## URBAN DESIGN PANEL

## RESPONSE TO URBAN DESIGN PANEL COMMENTS \_ ENTRANCE LOBBIES

**Re: Proposed Hotel, cnr Cambridge Terrace and Worcester Boulevard.**

RESPONSE TO URBAN DESIGN PANEL COMMENTS \_ SUN STUDY

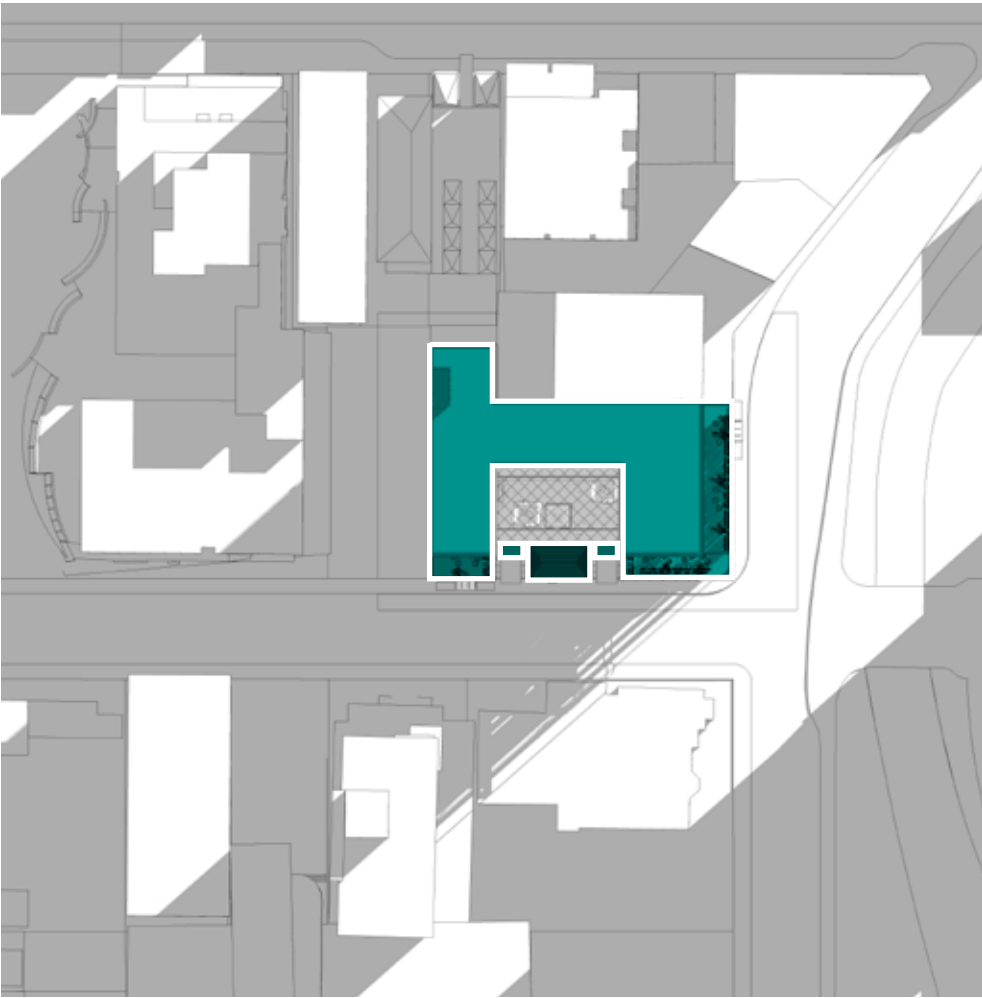
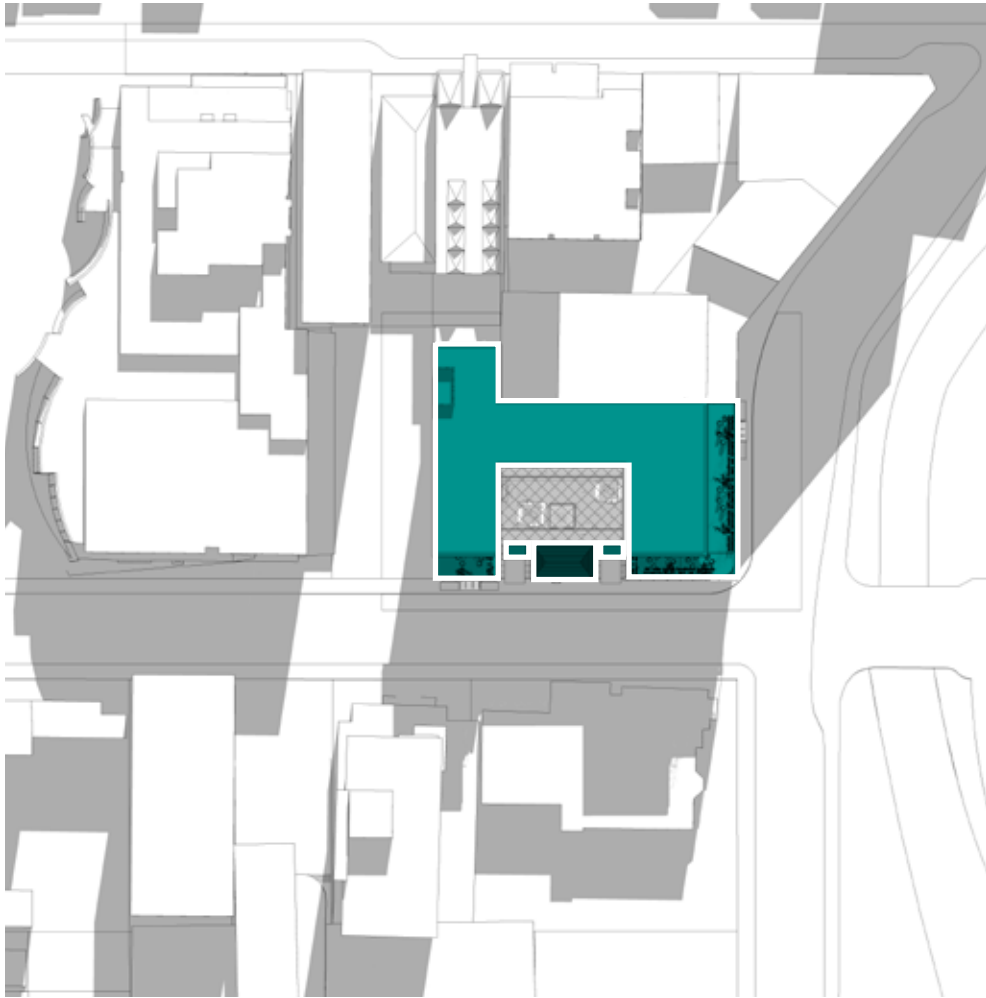
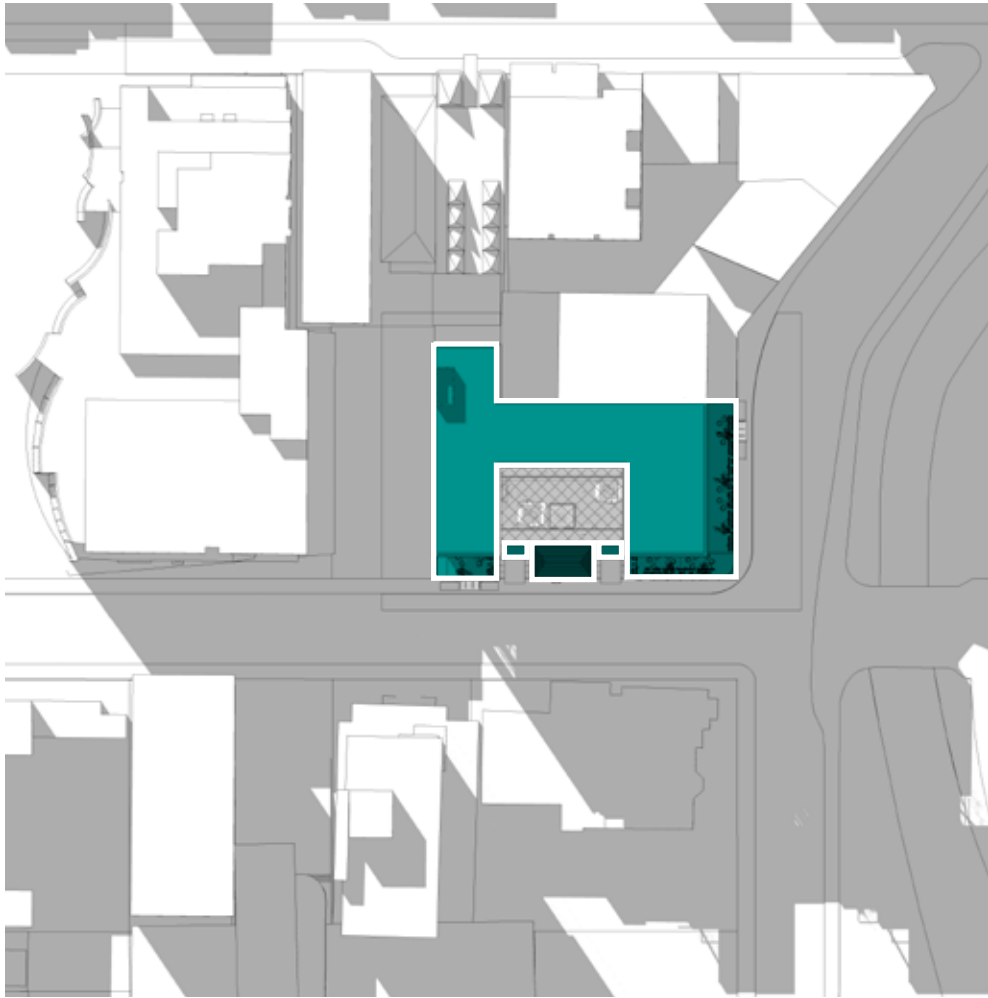
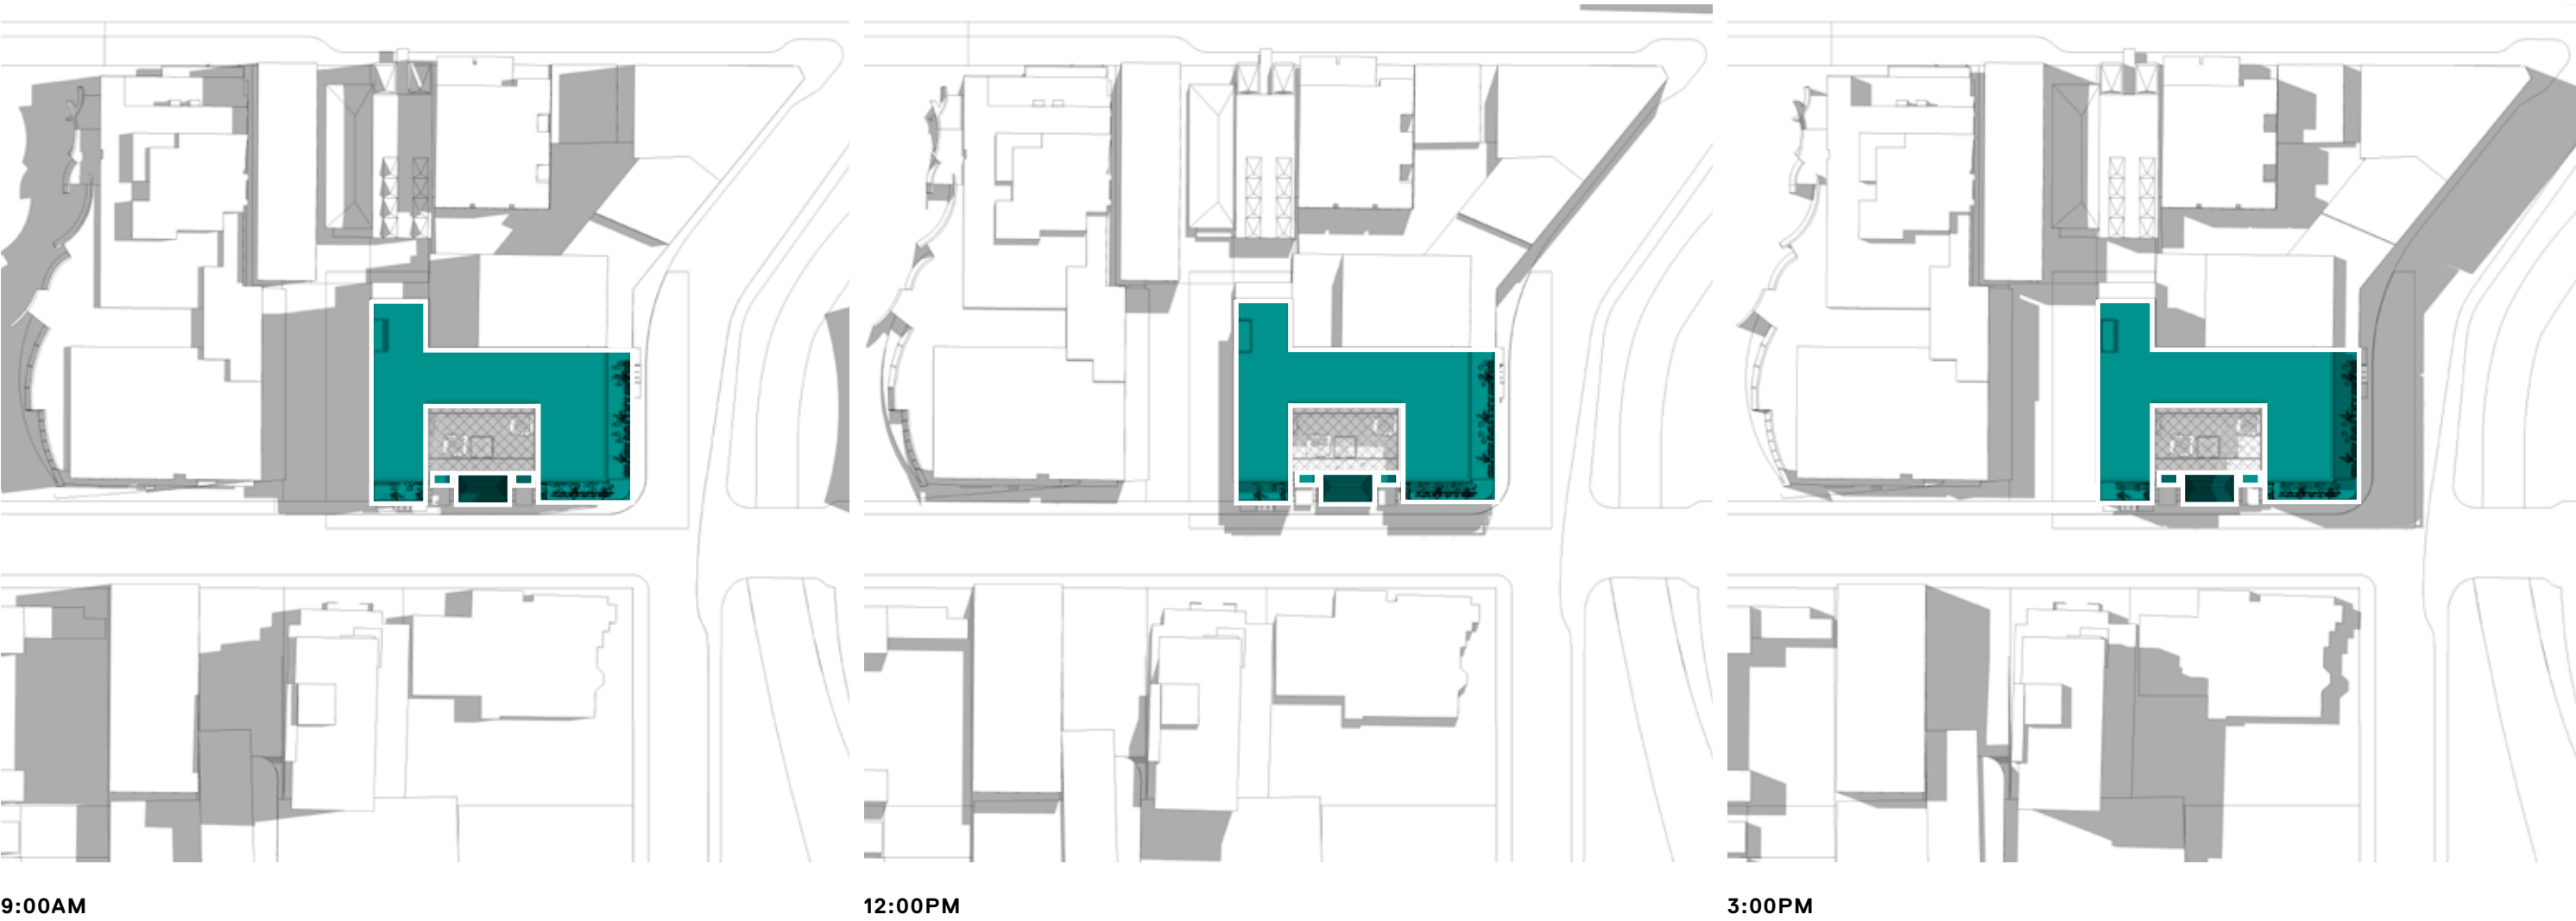
9.	Request shading diagrams as part of the consent package given the potential impact on public realm.
Shadings diagrams provided in the Appendix 05	
10.	Are supportive of the glazing on the west elevation to ensure this flank wall remains partially activated.
Noted

The parapet surface at LV7 is 650mm above the street frontage control,  
Images showing sun studies plans of the proposed height.
